Title: Directing Public Hearing to Consider Ordering the Morningside Stormwater Improvement Project

Resolution number: 25-012

Reference: Technical Review | Medina, Morningside Ravine Project | Land and Water Partnership (LWP) Program's Notice of Interest Submittals

GRADING PLAN

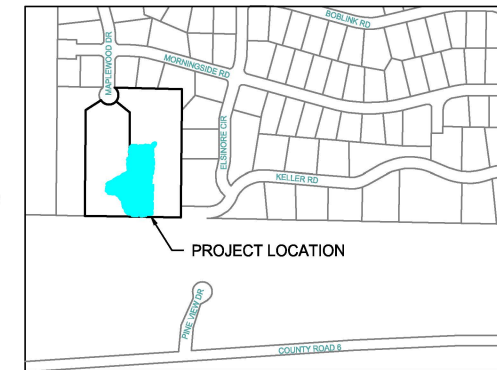
- Consider design alternatives downstream of the settling basin (located at the end of the existing 36-inch pipe) to reduce the amount of sheet piling required.
- Provide updated H&H Modeling to accurately demonstrate flows out of the settling basin and out of corresponding plunge pools that will require sheet piling.
- Consider the use of non-limestone angular riprap for channel restoration and step pools to increase project longevity.

The Shoreline & Streambank Stabilization Rule is triggered by the proposal to stabilize eroded ravines. The MCWD rule promotes the use of vegetative and bio-engineering solutions, where feasible. The plans have been updated to satisfy rule requirements and bioengineering methods, such as native seed mixes along the top of the slopes and live stakes, have been incorporated into the design. Furthermore, the pipe extension along the ravine has been replaced with a step pool design which includes riprap check dams enforced with sheet pile.
